Memorandum Planning and Urban Development Department Planning Division

Date: January 5th, 2018

Re: Level III Subdivision and Site Plan:
New three-unit residential condominium (4-stories)
 30 Fox Street
 Dyer Neck Development, LLC, Applicant
 Project # 2017-227 CBL:

Meeting Date: January 9th, 2018

The site

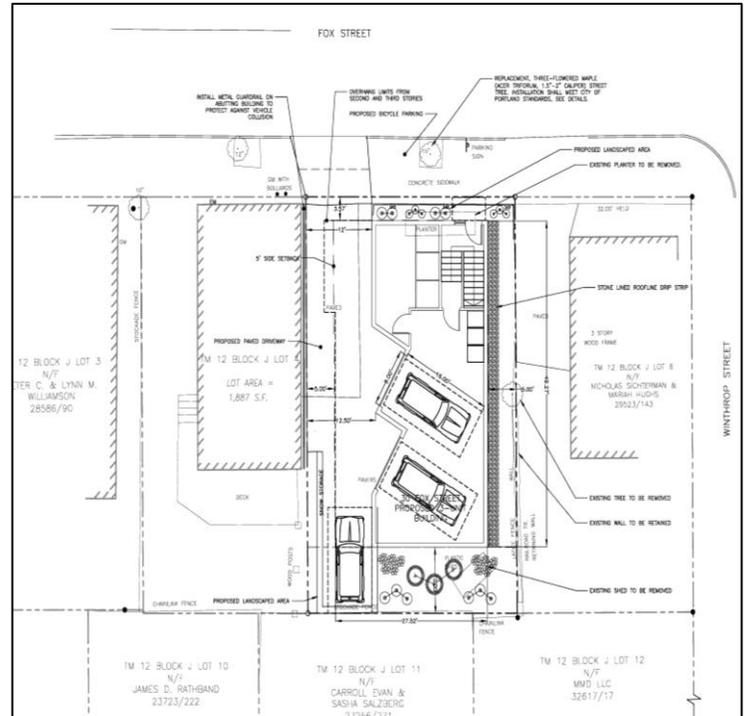
The site totals 2394 sq ft with a 38 foot frontage onto Fox Street. This lot and the lot to the west (with a single family home on a legally non-conforming lot) were both owned by the applicant. The applicant created a curb cut for the vacant lot and sold the lot with the home. To the east is a recently constructed single family home and to the south are the rear yards of similar residential properties. There are sections of existing fence along the boundaries.

There is an existing street tree in the ROW frontage and street parking is allowed on that side of Fox Street.
